Service Bulletin

SUBJECT: Service Update for Inventory Vehicles Only
Fuse Block Retention
Expires February 28, 2016

MODELS: 2015 Chevrolet Silverado HD
2015 GMC Sierra HD
Equipped With 220 Amp Generator (KW5)

Part Being Requested: **SERVICE UPDATE BULLETIN 14034 – WPC744**

3709060

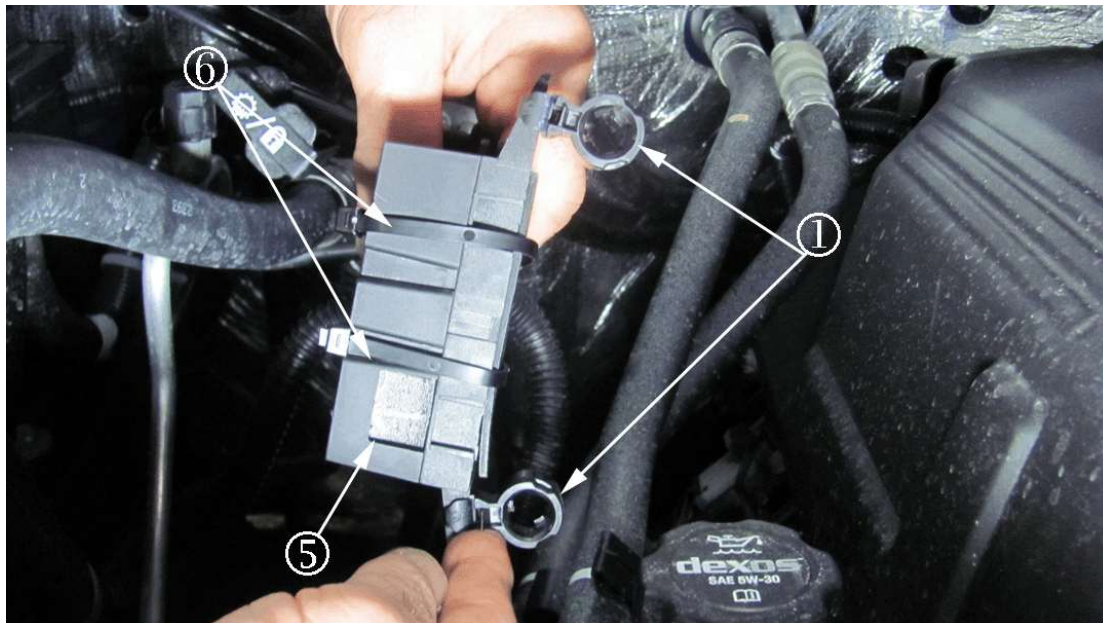
- A fuse block housing assembly that has NOT been reworked will have two brown clips (1) that secure the fuse block housing assembly to the shock tower studs. The fuse block housing cover will also NOT have a black polyolefin side window shield (5) or a black polyolefin bottom shield that is secured to the fuse block housing assembly with two black tie straps. **If the fuse block housing assembly rework has NOT been performed, perform the rework procedure in this bulletin. Proceed to step 3.**

3709065

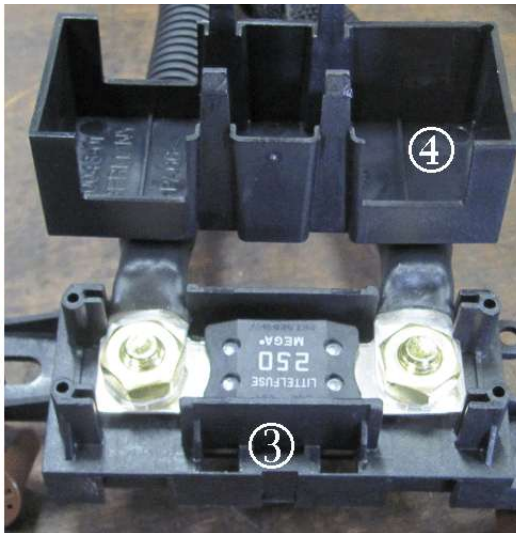
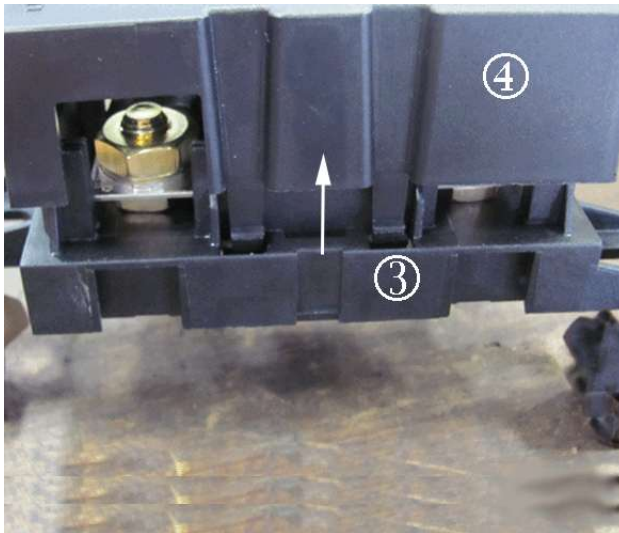
- A reworked fuse block housing assembly will have two black clips (1) that secure the fuse block housing assembly to the shock tower studs. The fuse block housing cover will also have a black polyolefin side window shield (5) and the bottom of the fuse block housing will have black polyolefin bottom shield that is secured to the housing assembly with two black tie straps (6). **If the rework has been completed, no further action is required.**
3. Disconnect the negative battery cable. Refer to Battery Negative Cable Disconnection and Connection in SI.

3709073

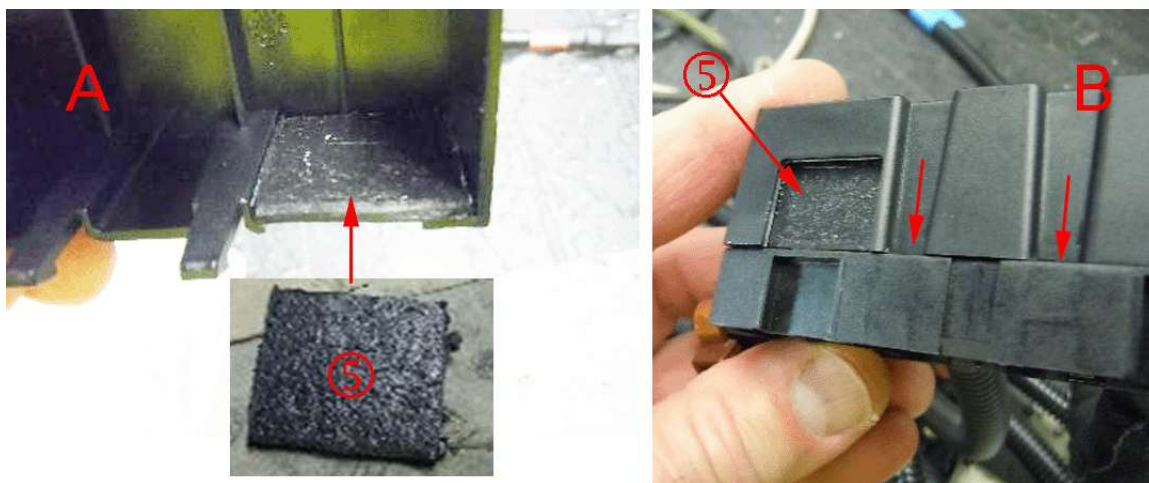
8. Determine if the cable routing is correct. The starter cable (1) routes forward of the other two fuse-center cables (2).
- If the cable routing is correct, proceed to step 9. Refer to the 'A' portion of the photograph for the correct routing of the cables. The starter cable (1) is forward of the two fuse center cables.
 - If the cable routing is NOT correct, unfasten the fuse center cable (2) that is to the right of starter cable (1). Refer to the 'B' portion of the photograph to view the incorrect routing of the cables. The starter cable (1) is routed in between the two fuse center cables. Reroute the right fuse center cable (2) to ensure the starter cable (1) is routed forward of the two center fuse cables. Next, re-install the fuse center cable (2) to the fuse block. Proceed to step 9 after correcting the cable routing.

3709077

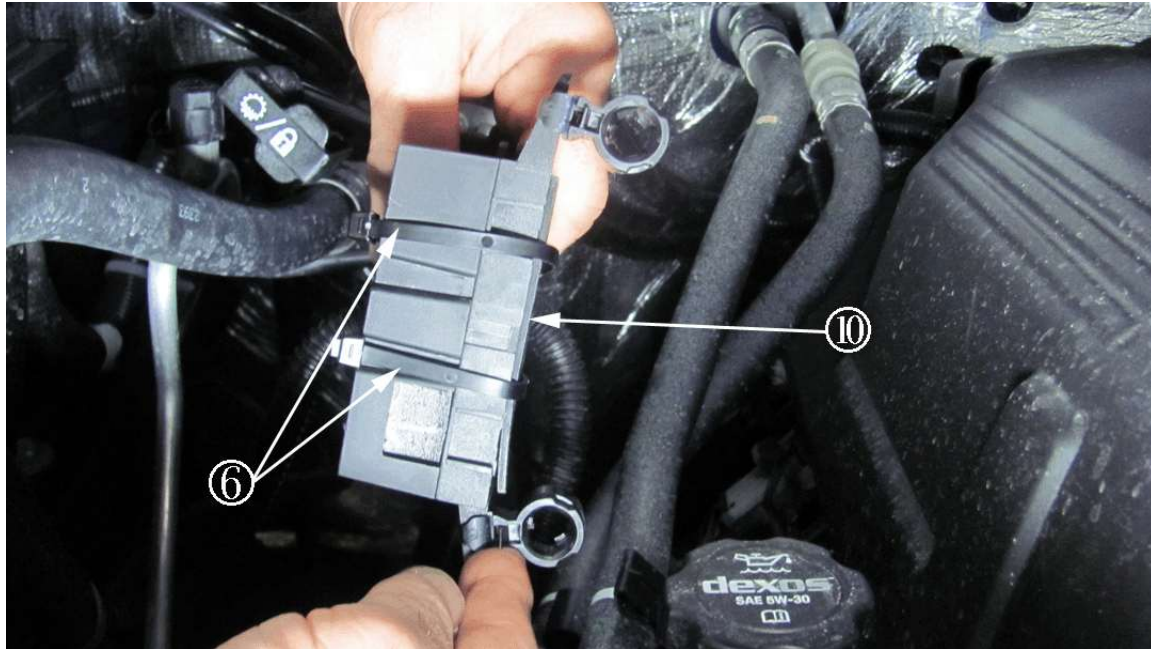
9. Insert a 23 x 26 mm (0.90 in x 1 in) black polyolefin shield inside the fuse block cover in the fuse block cover window area (5) as shown in the 'A' portion of the photograph.
10. Snap the fuse cover over the fuse block base as shown in the 'B' portion of the photograph. This will wedge the black polyolefin shield into place and close off the side fuse cover window (5).

3709038

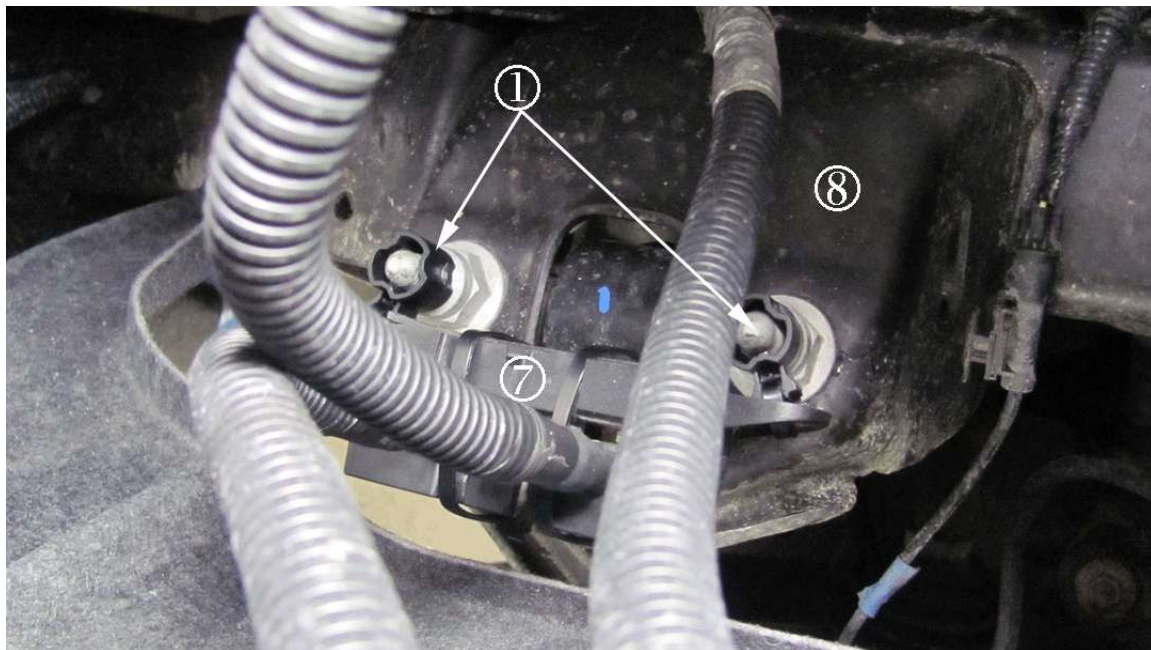
11. Place a 38 x 100 mm (1.5 in x 3.9 in) black polyolefin shield (10) over the bottom of the fuse block.
12. Secure the black polyolefin shield (10) to the bottom side of the fuse block using the two tie straps (6).
13. Pull the tie straps (6) tightly to secure the shield to the bottom side of the fuse block.
14. Cut the excess tail from the tie straps.
